### **OFFICIAL NOTICE AND AGENDA**

Meeting:	ZONING BOARD OF APPEALS
Members:	Nancy Hoffmann, David Burke, Mark Dillman, Dave Oberbeck, Jerry Jarosz, Nan Giese (Alternate), Arlene Kaatz (Alternate)
Location:	Council Chambers at City Hall, 407 Grant Street
Date/Time:	Wednesday, March 15, 2023, at 4:00 p.m.

## **STAFF REPORT**

### Subject: Variance for Athletic Lighting at East High School

## Wausau West Baseball Softball Wausau,WI

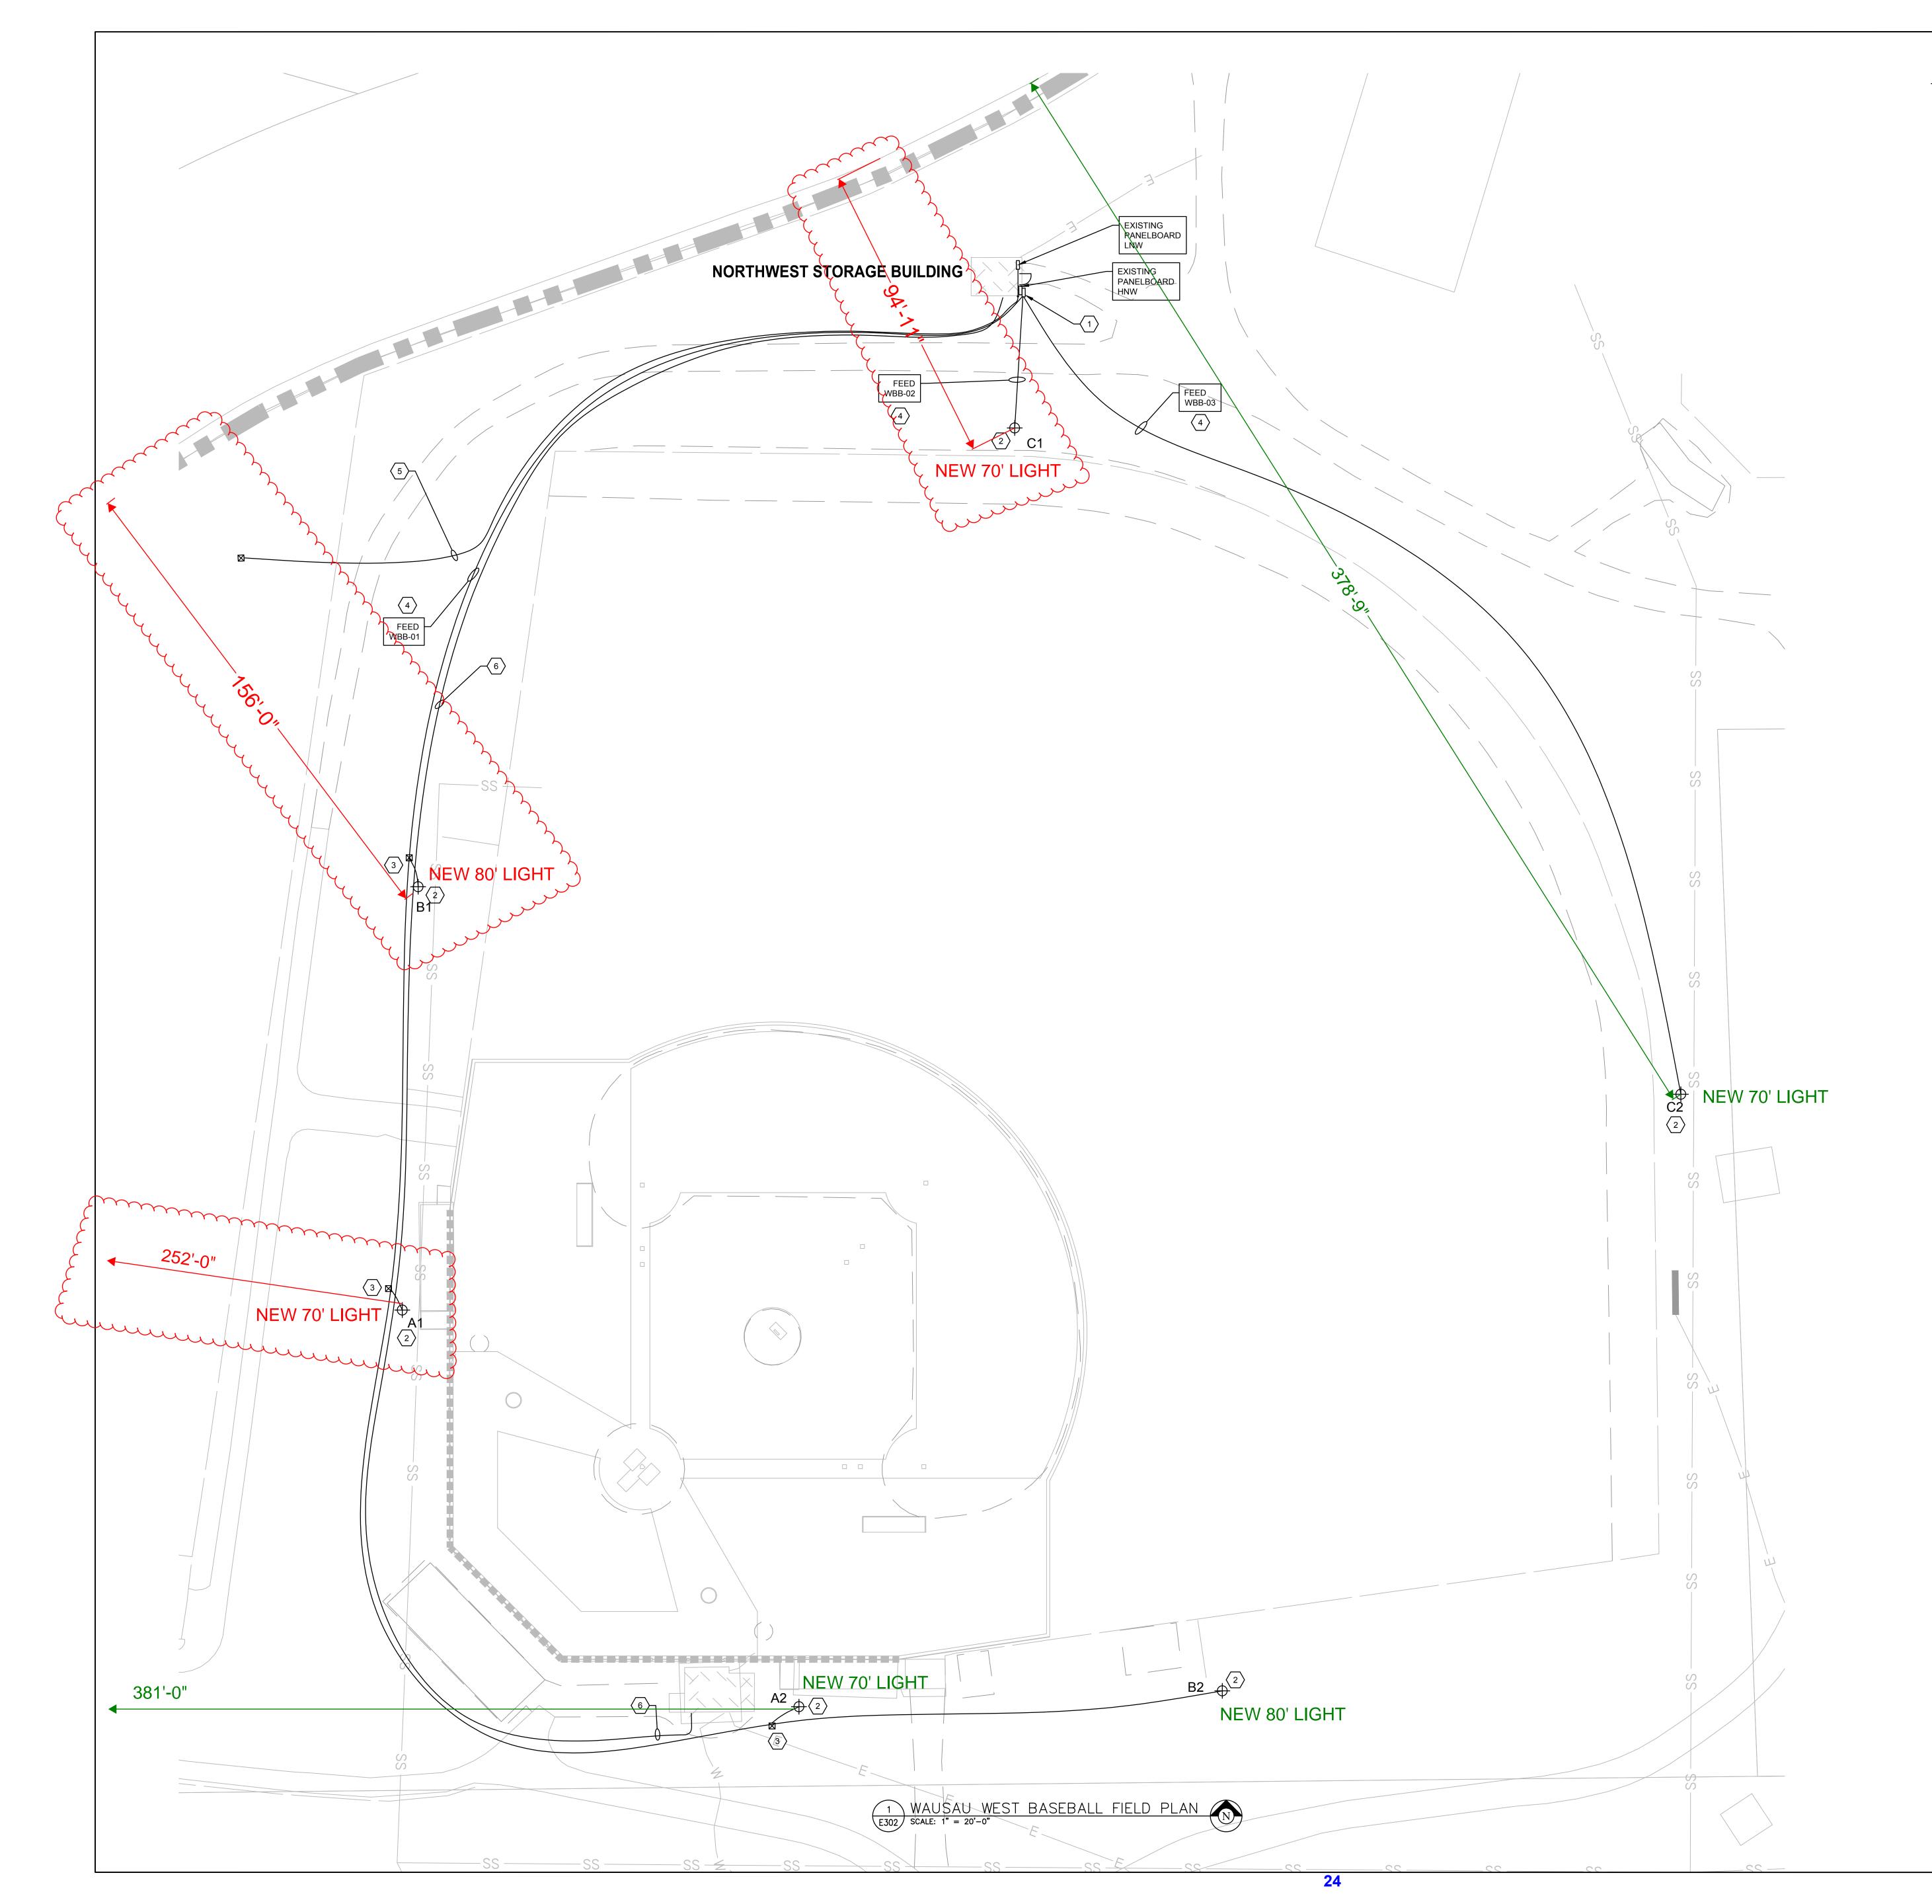
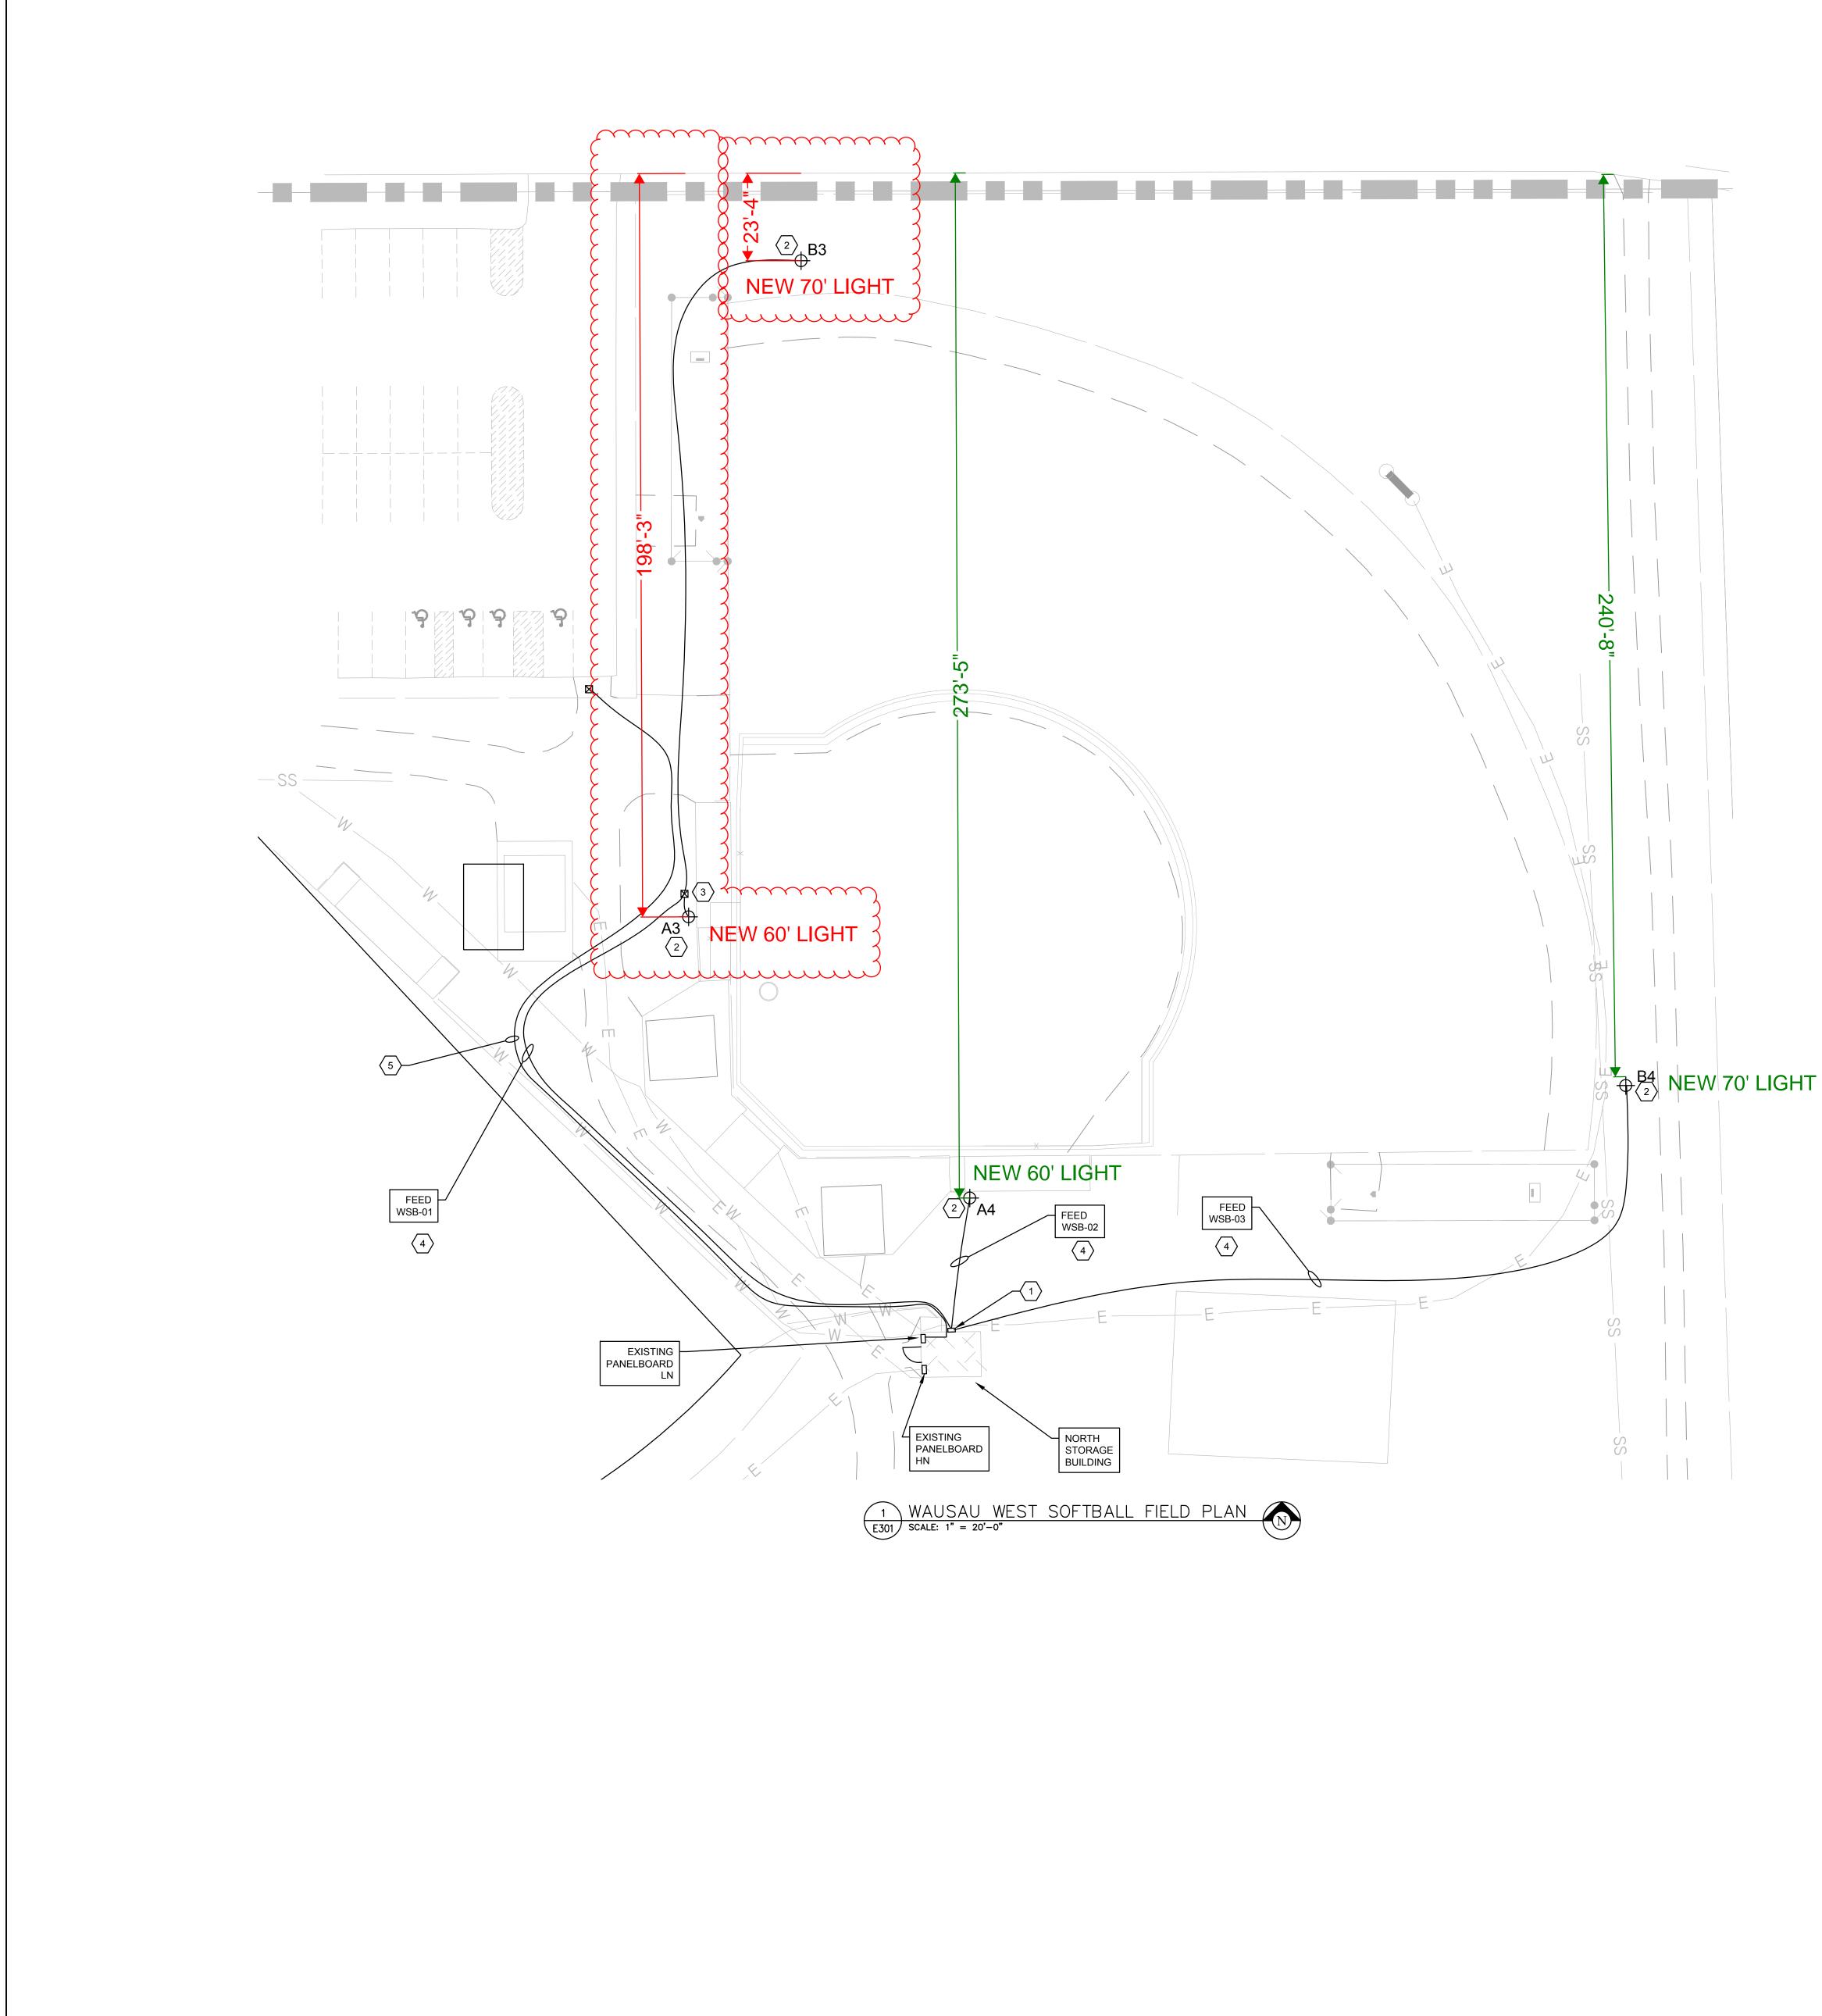
In your packet you will find plans showing the lighting pole height and distance to property lines. Poles that need a variance are clouded around and show pole height and distance to property lines. Also, photometric lighting plans have been included showing that no light spillage will occur over the property lines.

Engineered plans show no light spillage at the property line. The right-of-way at Stevens Drive is larger than a typical city street, 78 feet wide versus 60 feet. That does give a little more separation from the light poles to the neighboring homes along Stevens Drive.

The softball field does have some tight setbacks to the property lines. The pole height being proposed helps to reduce the number of poles that would need to be placed and it is designed to allow for adequate lighting for the athletes to play safely. This field is immediately adjacent to a parking lot serving the field and the field is served by a press box.
